## **Addendum No. 2**

Re: Hillsdale Senior Center Roof Replacement  
Project # PR-049a-25

Date: September 15, 2025

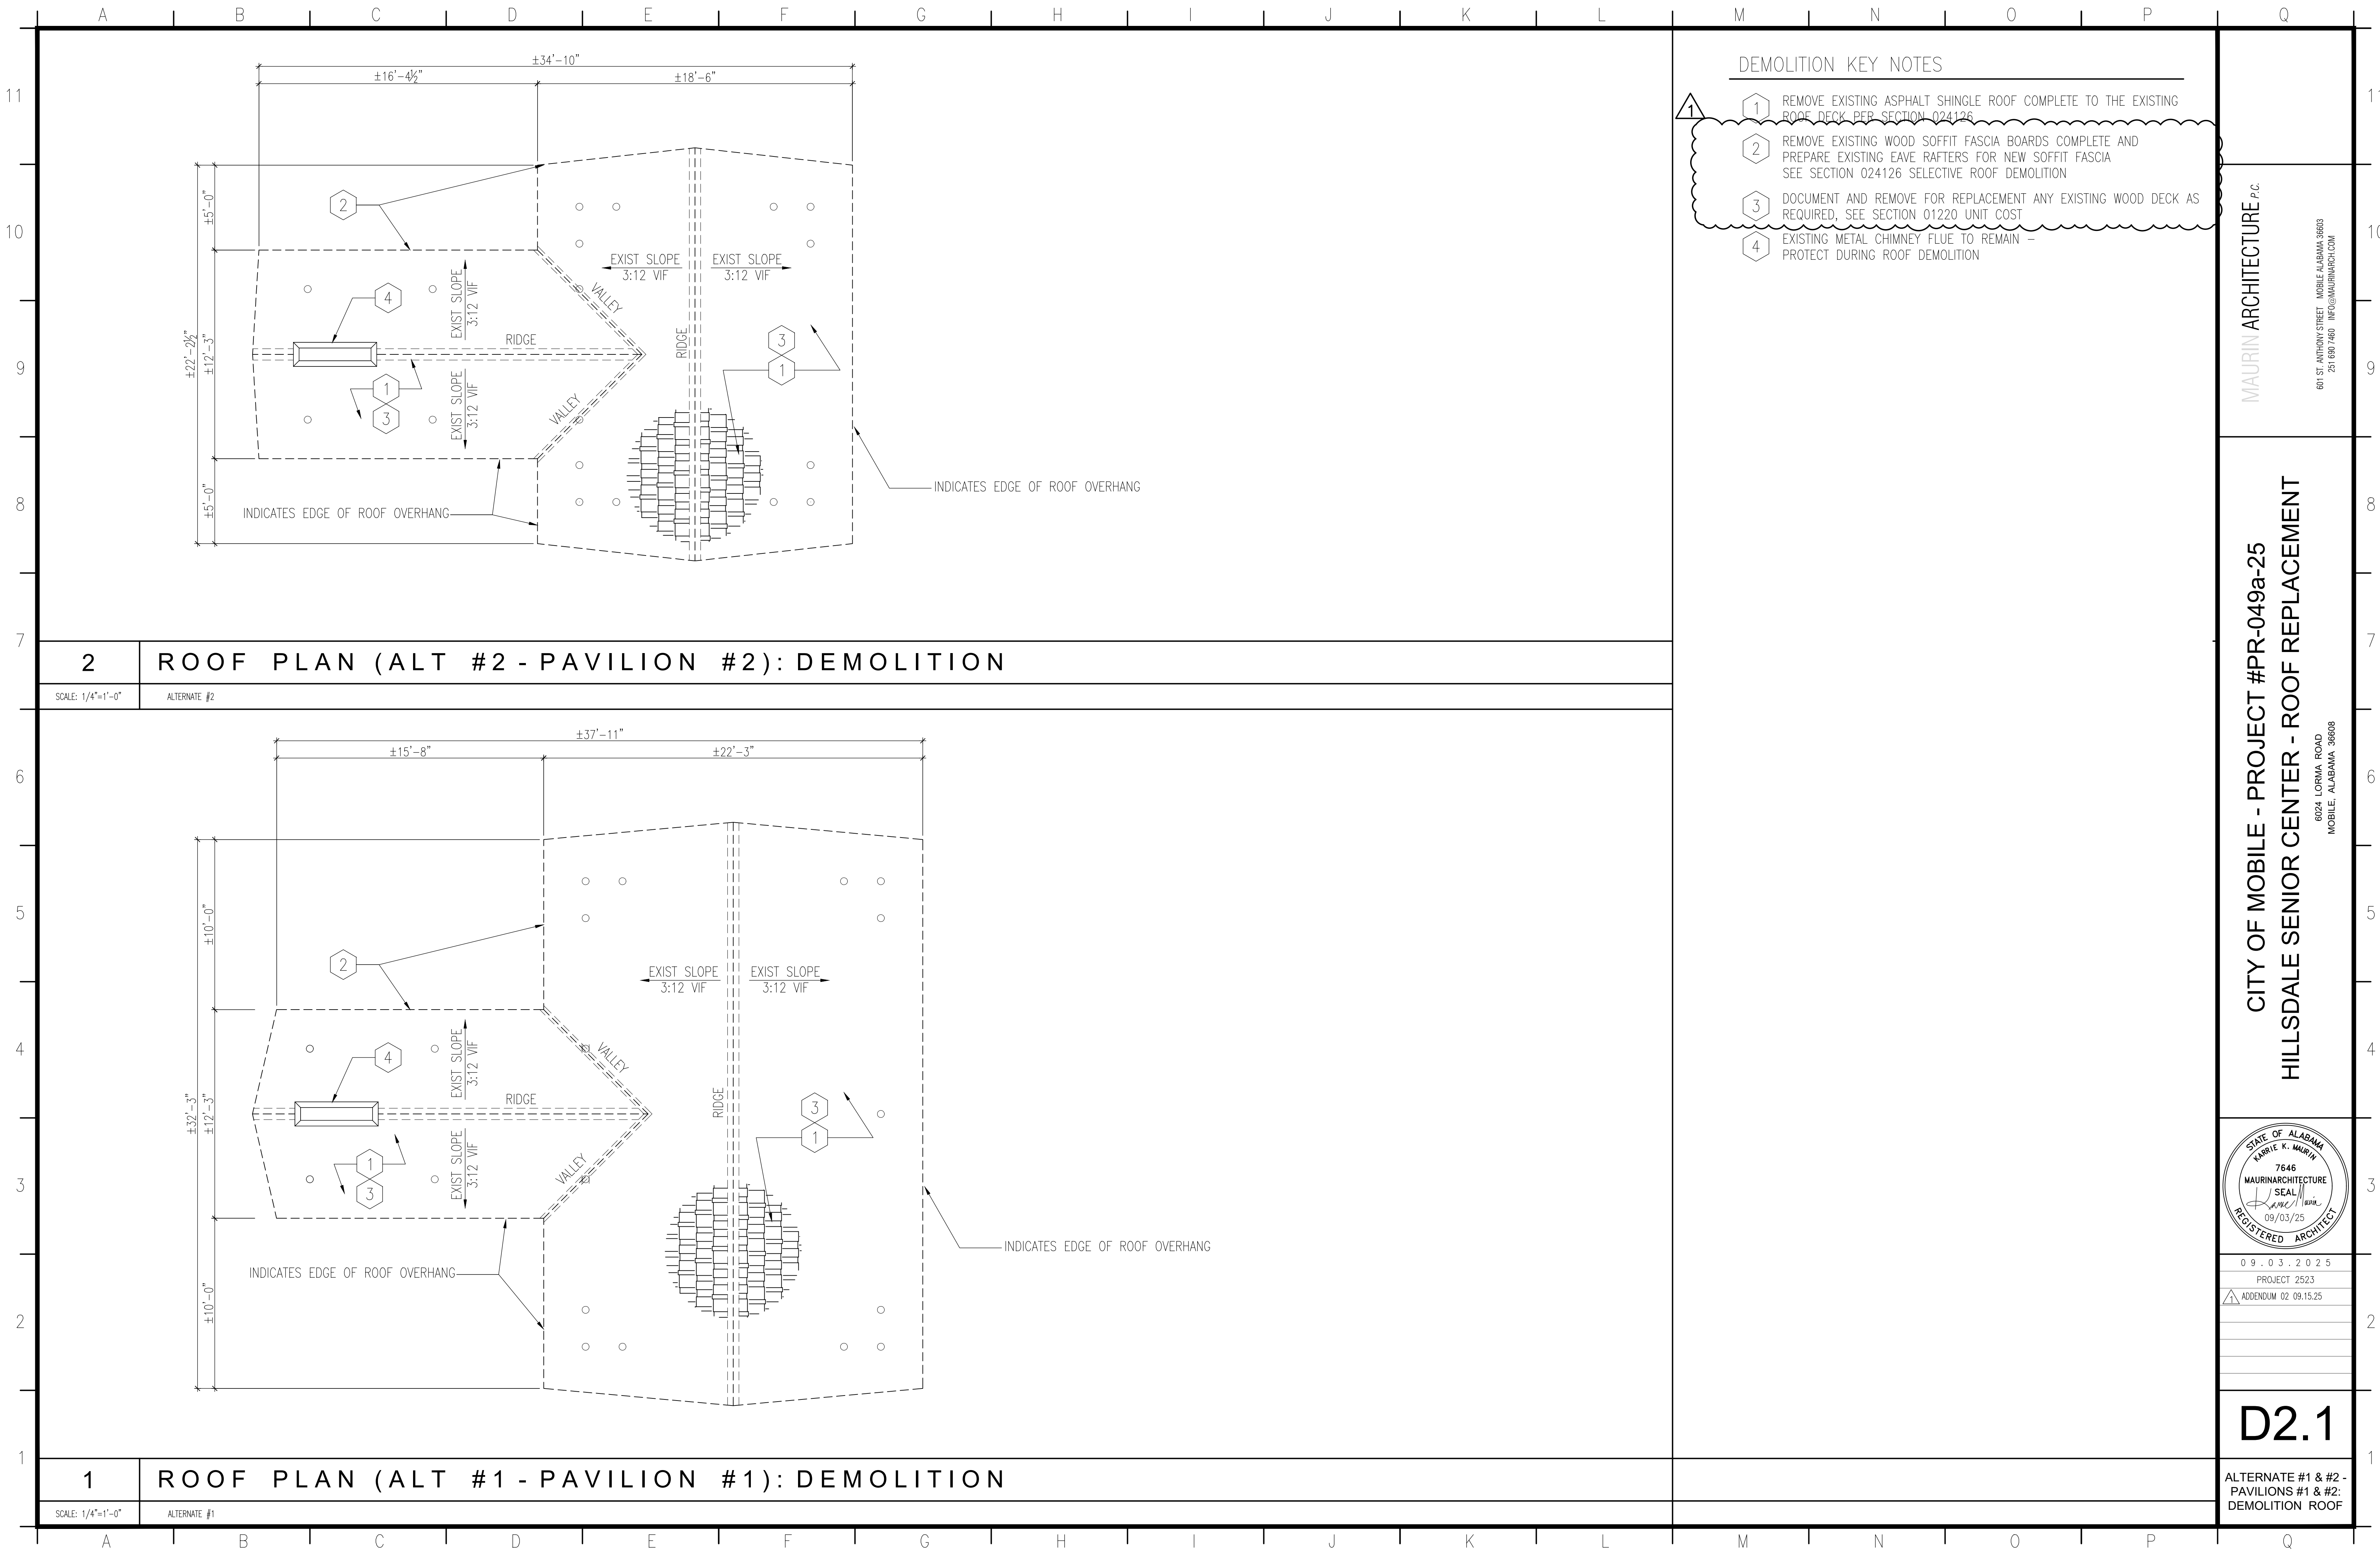
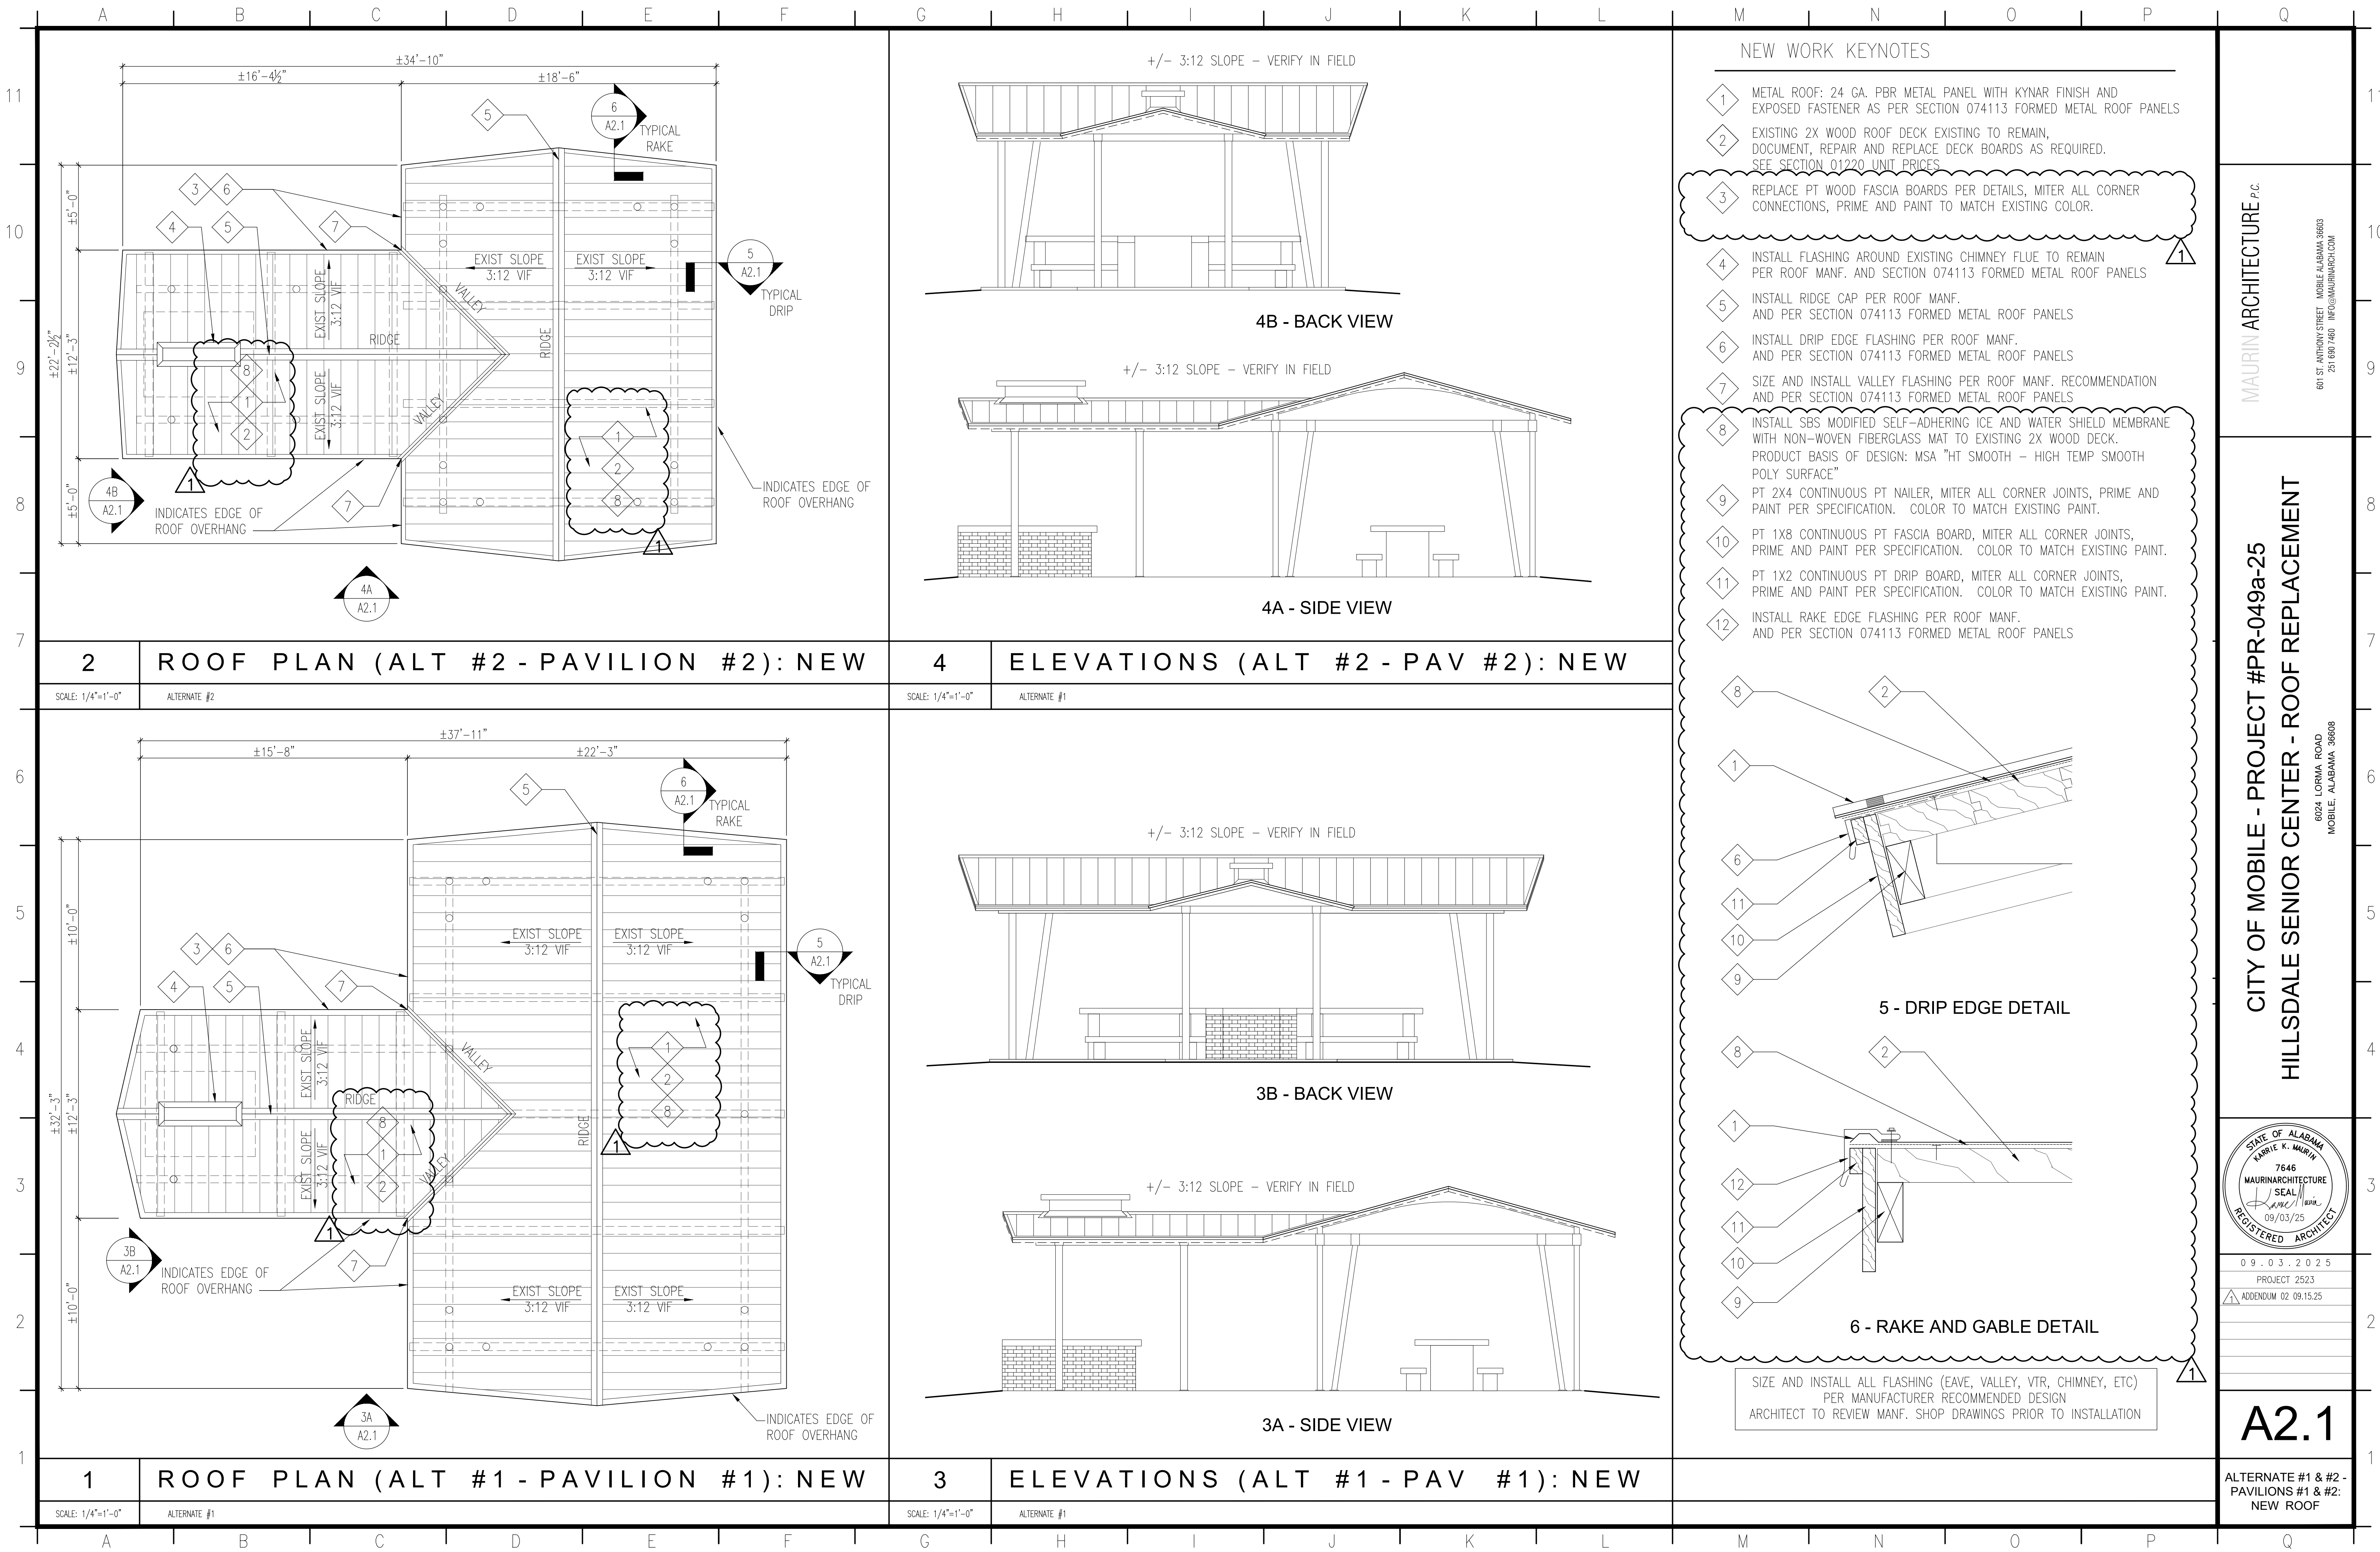
Item 1. A vapor barrier is required for the Pavilion roofs. See attached revised plans.

- a. Duro-Last
      - b. Peterson Aluminum Corporation (PAC-CLAD)
- Item 4. Revised plans will be provided to the awarded bidder with updates matching the roof assembly provided in Addendum #2 (Clarification Items 2 & 3 above).

- Item 1. Replace drawings sheet titled T1.0 Title Sheet and dated 9.03.25 with this one attached by the same title and dated 9.15.25.
- Item 2. Replace drawings sheet titled D2.1 Alternates #1 & #2: Demolition Roof Plans and dated 9.03.25 with this one attached by the same title and dated 9.15.25.
- Item 3. Replace drawings sheet titled A2.1 Alternates #1 & #2: New Roof Plans and dated 9.03.25 with this one attached by the same title and dated 9.15.25.
